CLIENT & PROJECT TEXAS UTILITIES GENERATING CO/COMANCHE PEAK SES				PAGE : OF 13 TOTAL NO OF PAGES -21	
CALCULATION TITLE (Indicative of the Objective): Cable Ampacity Derating Factors for Conduits Boxed In With Thermolog (TSI Product)				TE SAFETY CLASSIFICATION <input checked="" type="checkbox"/> Class I <input type="checkbox"/> Class II <input type="checkbox"/> Non-Safety	
CALCULATION IDENTIFICATION NUMBER					
J.O. OR W.O. NO.	DIVISION & GROUP	CURRENT CALC. CO.	OPTIONAL TASK CODE	OPTIONAL WORK PACKAGE NO.	
16345/6	EE (B)	004	XXX	13L	
*APPROVALS - SIGNATURE & DATE			REV. NO. OR NEW CALC. NO.	SUPPLEMENTS/ SUPERCEDES CALC./REV NO.	CONFIRMATION REQUIRED (✓)
PREPARER(S)/DATE(S)	REVIEWER(S)/DATE(S)	INDEPENDENT REVIEWER(S)/DATE(S)			YES NO
<i>Keith Petty 2-20-87</i> KEITH A. PETTY	<i>H.V. Redgate 2-24-87</i> H.V. REDGATE	<i>H.V. Redgate 2-24-87</i> H.V. REDGATE	0	N/A	✓
DISTRIBUTION					
GROUP	NAME & LOCATION	GROUP	NAME & LOCATION

COMANCHE PEAK STEAM ELECTRIC STATION UNIT 2 DESIGN CHANGE AUTHORIZATION					DCA NO. REVISION <u>16093</u> <u>0</u> PAGE 1 OF <u>9</u>
1. LOCATION <u>UNIT 2 & COMMON</u>		2. EQUIPMENT/COMPONENT I.D. NO. <u>N/A</u>

3. SYSTEM/SUBSYSTEM/AREA NO. <u>GENERIC</u>

RC-1

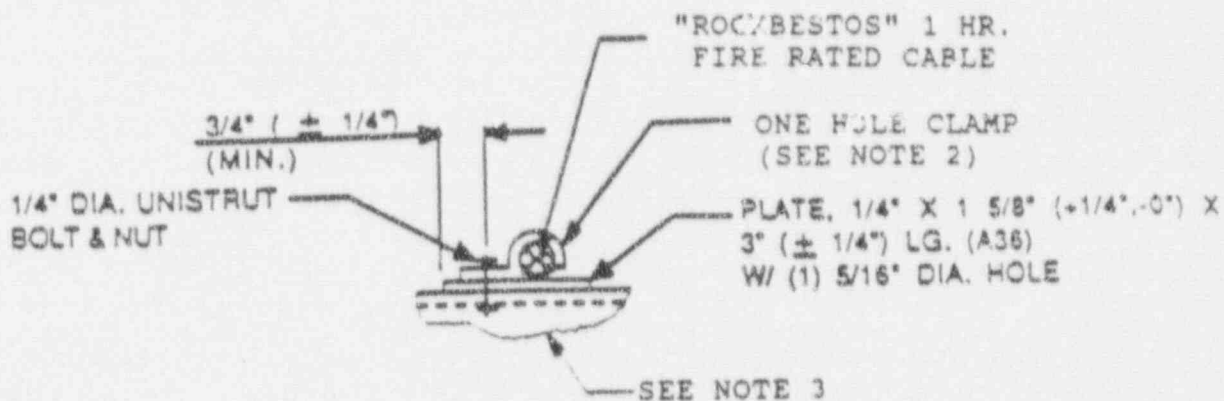
8. DETAILS OF CHANGE <u>NEW DETAILS SHOWN ON FOLLOWING PAGES ADDED FOR SUPPORT OF ROCKBESTOS CABLE INSTALLATIONS.</u> <u>"MEL" IS NOT AFFECTED BY THIS DESIGN CHANGE.</u>

1. MAXIMUM SUPPORT SPACING TO BE 6'-0" U.O.N.
2. FOR ACCEPTABLE CLAMPS FOR USE WITH THIS DETAIL, SEE TABLE BELOW:

3. TO BE USED WITH SUPPORT TYPE US-1 ONLY.
FOR SUPPORT DETAILS NOT SHOWN, SEE DRAWING S2-0910 SH. PESD 3-7, REV. CP-3.
4. FOR WET AREA INSTALLATION, A SPACER IS REQUIRED BETWEEN THE CABLE AND THE PLATE. SPACER IS TO BE O-Z GEDNEY 141G FOR #8 AWG CABLE AND O-Z GEDNEY 142G FOR 1/0 CABLE.
5. FOR DETAILS NOT SHOWN, REFER TO DRAWING NO. S2-0910 SH. PESD-1-6, REV. CP-2.

RC-1

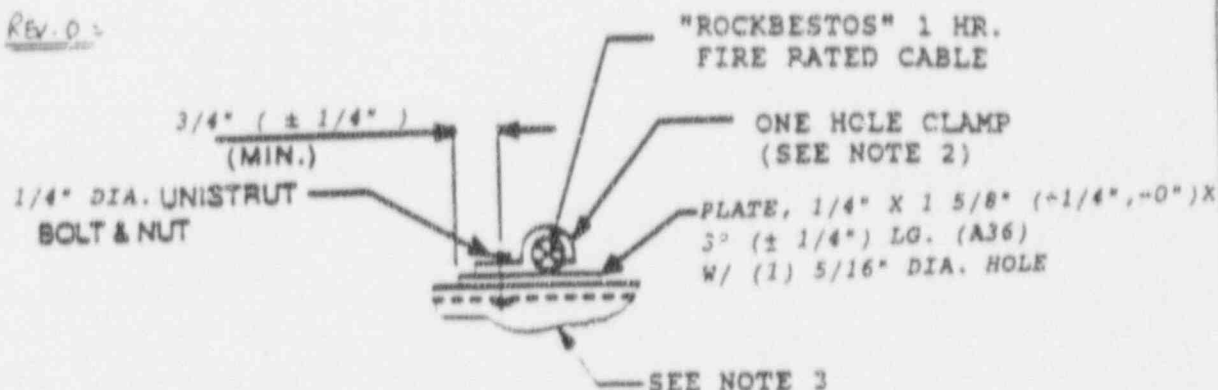
1 LOCATION UNIT 2 & COMMON		2 EQUIPMENT/COMPONENT I.D. NO.: NA	
3 SYSTEM/SUBSYSTEM/AREA NO. GENERIC		4 INITIATING DOCUMENTS I.D. NO.: NA	
5 PROBLEM DESCRIPTION/PROPOSED CHANGE (OPTIONAL): REV. 2: CONSTRUCTION REQUEST TO PROVIDE DEFINITION OF ROCKBELTOS FIRE RATED CABLE SPANS.			
6 DISCIPLINE <input type="checkbox"/> BG <input type="checkbox"/> EM <input type="checkbox"/> PR <input checked="" type="checkbox"/> SD <input type="checkbox"/> CT <input type="checkbox"/> MECH. <input type="checkbox"/> ELECT. <input type="checkbox"/> C/S <input type="checkbox"/> I&O <input type="checkbox"/> HVAC <input type="checkbox"/> OTHER (SPECIFY)			
7 B.M. NOTE ORIGINATED BY: B.M.		8 DATE: 1/6/92 ORGANIZATION: AEE IMPER. EXT. 8007	
9 DETAILS OF CHANGE REV. 2: ADD NOTE (E) ILL TO DWG. NO. S2-0910 SH. PESD-1-6 REV. CP-2 AS SHOWN ON PG. 9 OF 9.			
10 ENGINEERING BASIS REV. 2: THIS NOTE IS TO CLARIFY THE APPLICATION OF ROCKBELTOS FIRE RATED CABLE SPANS PER DESIGN CRITERIA & THIS CHANGE MAY HAVE NO IMPACT ON CALC. NO. 0218-00-0094 REV. 1, HENCE THIS CHANGE IS ACCEPTABLE.

1. MAXIMUM SUPPORT SPACING TO BE 6'-0" U.O.N.
2. FOR ACCEPTABLE CLAMPS FOR USE WITH THIS DETAIL, SEE TABLE BELOW:

3. TO BE USED WITH SUPPORT TYPE US-1 ONLY.
FOR SUPPORT DETAILS NOT SHOWN, SEE DRAWING S2-0910 SH. PESD 3-7, REV. CP-3.
4. FOR WET AREA INSTALLATION, A SPACER IS REQUIRED BETWEEN THE CABLE AND THE PLATE. SPACER IS TO BE O-Z GEDNEY 141G FOR #8 AWG CABLE AND O-Z GEDNEY 142G FOR 1/0 CABLE.
5. FOR DETAILS NOT SHOWN, REFER TO DRAWING NO. S2-0910 SH. PESD-1-6, REV. CP-2.

RC-1

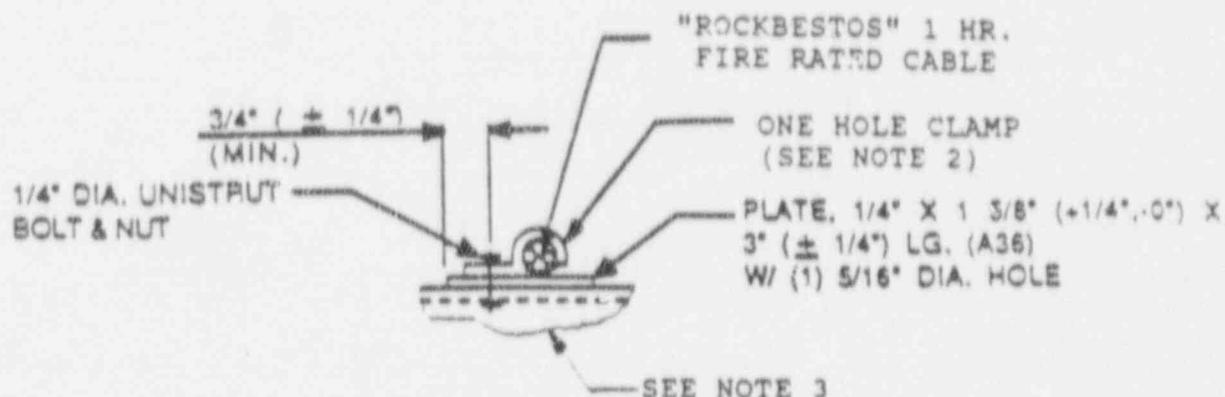
7. ORIGINATED BY: W.L. SANDERS DATE: 8-15-91 ORGANIZATION: ABB IMPELL EXT: 6388 APPROVAL: [Signature] DATE: 9/1/91									
8. DETAILS OF CHANGE NEW DETAILS SHOWN ON FOLLOWING PAGES ADDED FOR SUPPORT OF ROCKBESTOS CABLE INSTALLATIONS. "MEL" IS NOT AFFECTED BY THIS DESIGN CHANGE.

1. MAXIMUM SUPPORT SPACING TO BE 6'-0" U.O.N.
2. FOR ACCEPTABLE CLAMPS FOR USE WITH THIS DETAIL, SEE TABLE BELOW:

3. TO BE USED WITH SUPPORT TYPE US-1 ONLY. FOR SUPPORT DETAILS NOT SHOWN, SEE DRAWING S2-0910 SH. PESD 3-7, REV. CP-3.
4. FOR WET AREA INSTALLATION, A SPACER IS REQUIRED BETWEEN THE CABLE AND THE PLATE. SPACER IS TO BE O-2 GEDNEY 141G FOR #8 AWG CABLE AND O-2 GEDNEY 142G FOR 1/0 CABLE.
5. FOR DETAILS NOT SHOWN, REFER TO DRAWING NO. S2-0910 SH. PESD-1-6, REV. CP-2.
